Consumers
Power
Company

March 21, 1975

In accordance with Condition 4 of Memorandum and Order ALAB-106 dated March 26, 1973, and Amendment No 1 to the Midland Plant Construction Permit, enclosed are two copies of the nonconformance reports for February 1975. This report consists of copies of Bechtel Nonconformance Reports, Quality Assurance Discrepancy Reports, and Quality Audit Findings written or closed during the month; all sheets from the Bechtel Nonconformance Report Log and Status Book which reflect open Bechtel NCR's; and Consumers Power Company Nonconformance Reports written or closed during the month.

NONCONFORMANCE - REPORT LOG & STATUS BOOK

DRAWING NO.
FSK-C-296

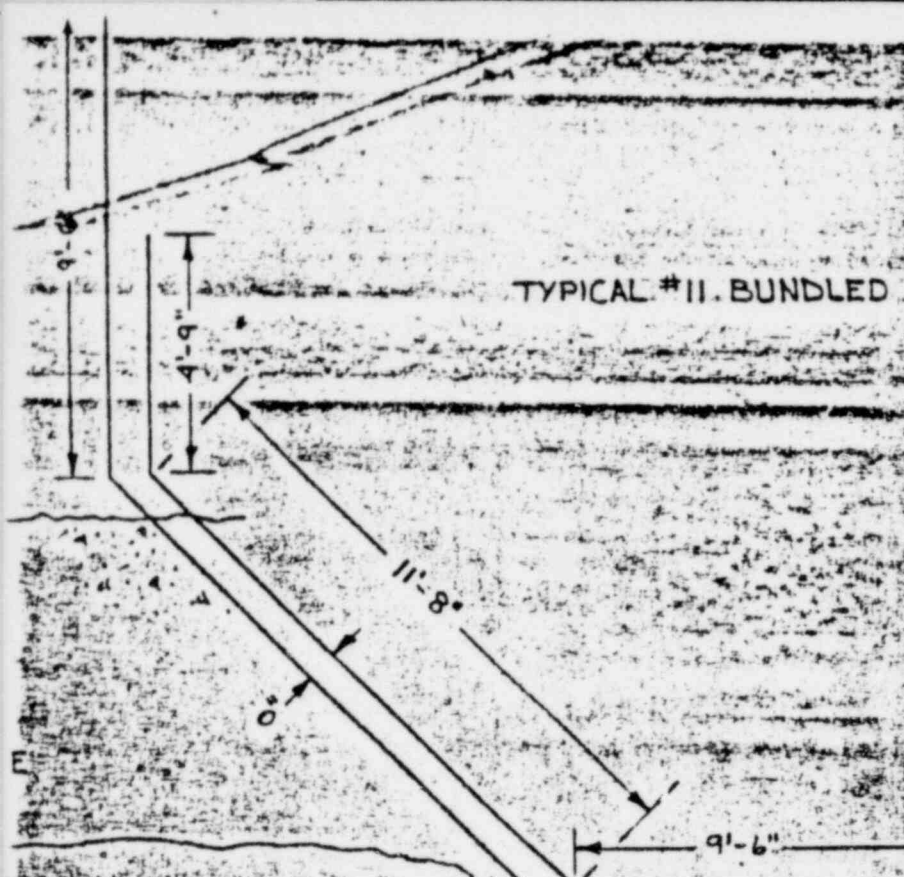
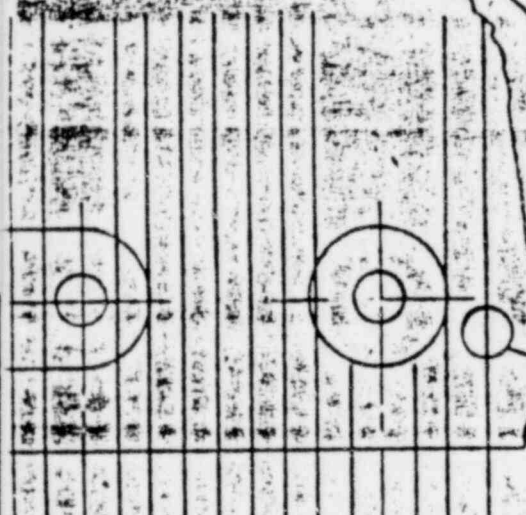
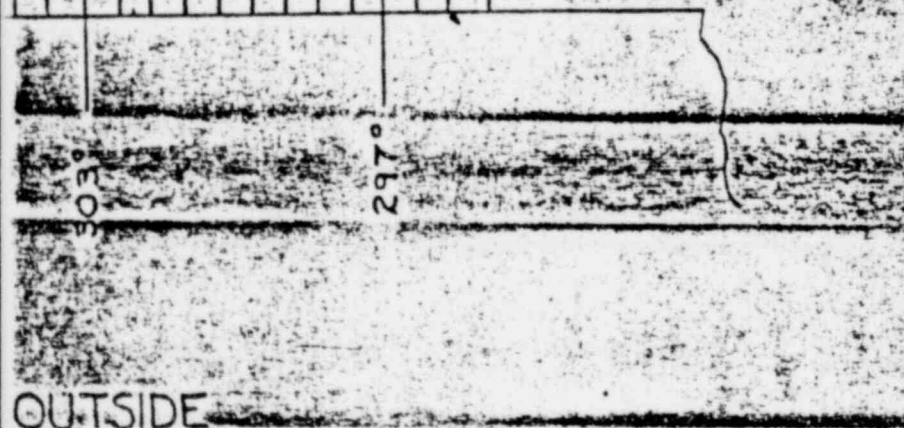
19. NONCONFORMING CONDITION:
 8-2 #11 bundled hauch bars were cut off to make room for the penetrations welded to the liner plate at El. 596'-0 in Reactor Building #2. The attached Drawing FSK-C-296 shows the #11 bars that were cut off. These bars do not conform to Section A of Drawing C-324, Rev. 10. The Q number for rebar is 1.103. The item was noted during liner plate installation record review.

We request that you issue an NCR for the above mentioned subject since it was a deviation from the design drawing. Our review has indicated that the as built condition is structurally adequate, and we will approve the NCR to "use-as-is" when it is received in our office.
